ATTACHMENT 2C

MPS3 EAL TECHNICAL BASES DOCUMENT (Marked-up)

**Dominion Energy Nuclear Connecticut, Inc. (DENC)
Millstone Power Station Unit 3 and ISFSI**

**Emergency Action Level Technical Bases Document
Millstone Power Station – Unit 3**

Figure 1: Containment Integrity or Bypass Examples

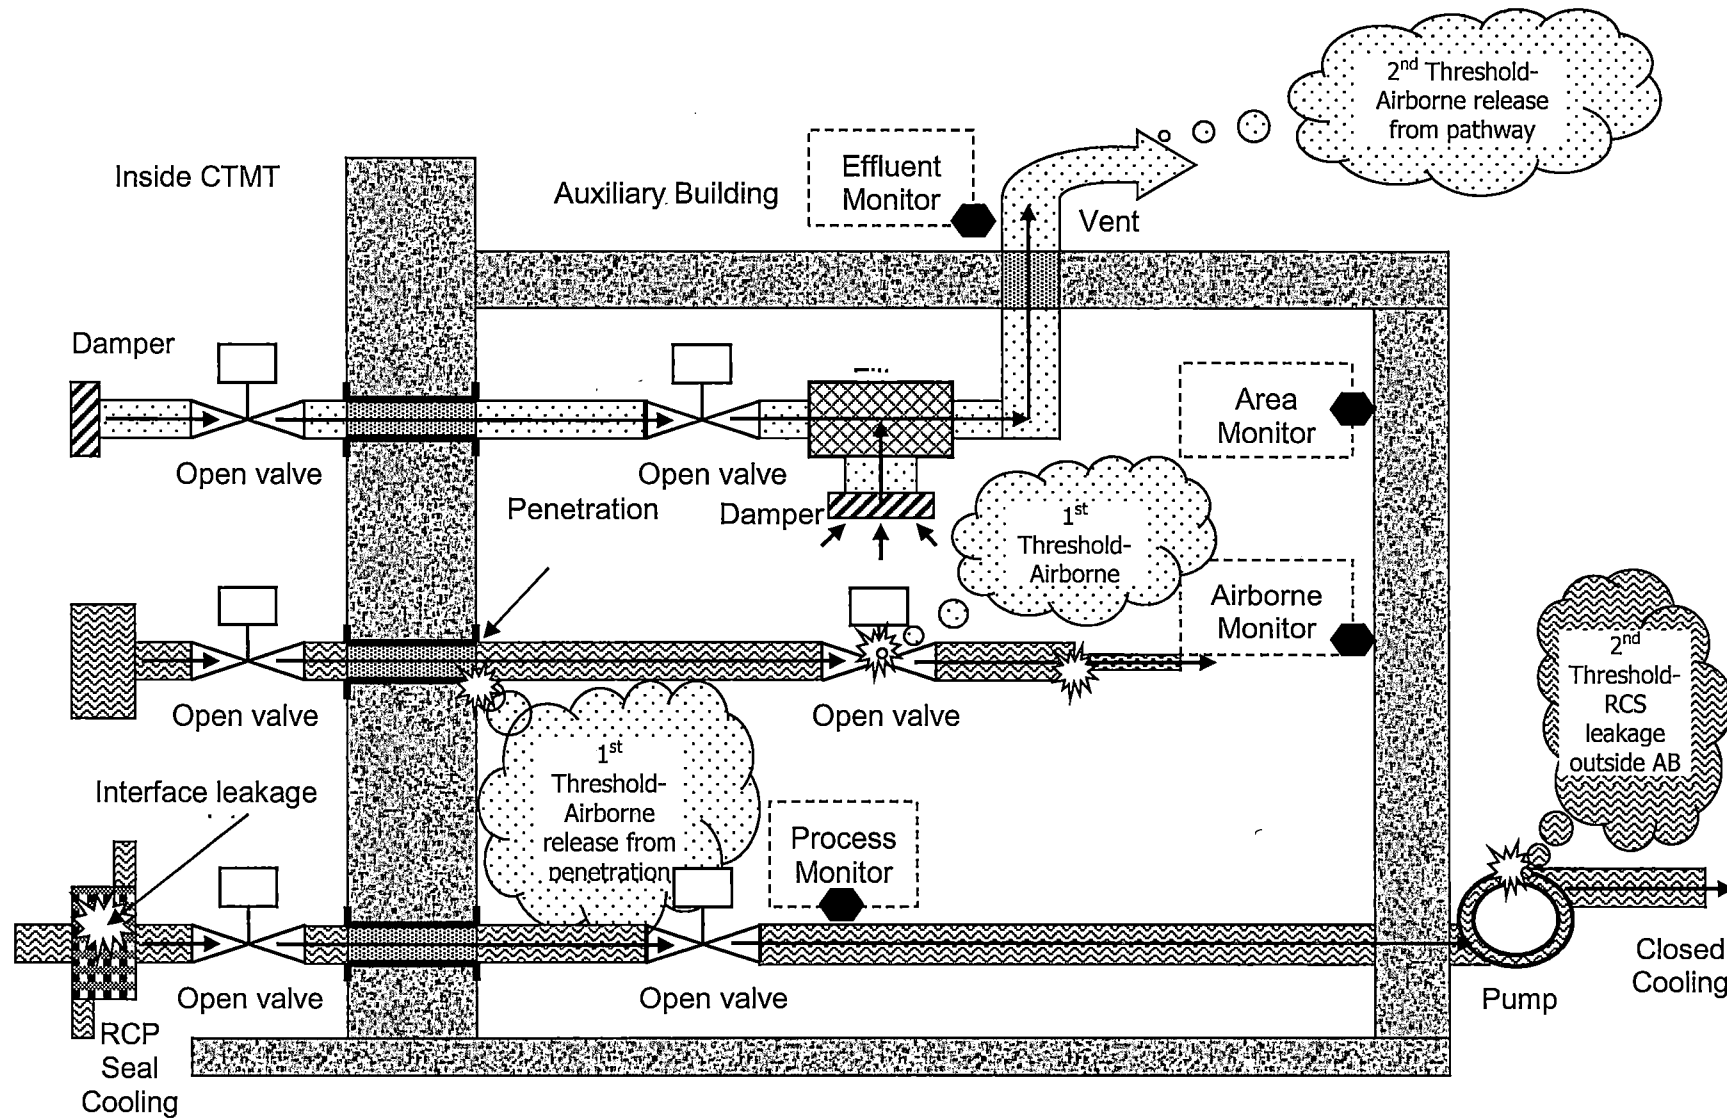
Refer to the middle piping run of Figure 9-F-41. Two simplified examples are provided. One is leakage from a penetration and the other is leakage from an in-service system valve. Depending upon radiation monitor locations and sensitivities, the leakage could be detected by any of the four monitors depicted in the figure.

Refer to the top piping run of Figure 9-F-41. In this simplified example, the inboard and outboard isolation valves remained open after a containment isolation was required (i.e., containment isolation was not successful). There is now an UNISOLABLE pathway from the containment to the environment.

Refer to the bottom piping run of Figure 9-F-41. In this simplified example, leakage in an RCP seal cooler is allowing radioactive material to enter the Auxiliary Building. The radioactivity would be detected by the Process Monitor. If there is no leakage from the closed water cooling system to the Auxiliary Building, then no threshold has been met. If the pump developed a leak that allowed steam/water to enter the Auxiliary Building, then the second threshold 4.B would be met. Depending upon radiation monitor locations and sensitivities, this leakage could be detected by any of the four monitors depicted in the figure and cause the first threshold 4.A.1 to be met as well.

Refer to the middle piping run of Figure 9-F-41. In this simplified example, a leak has occurred at a reducer on a pipe carrying reactor coolant in the Auxiliary Building. Depending upon radiation monitor locations and sensitivities, the leakage could be detected by any of the four monitors depicted in the figure and cause loss threshold ~~CNB4-D.2~~ to be met as well.
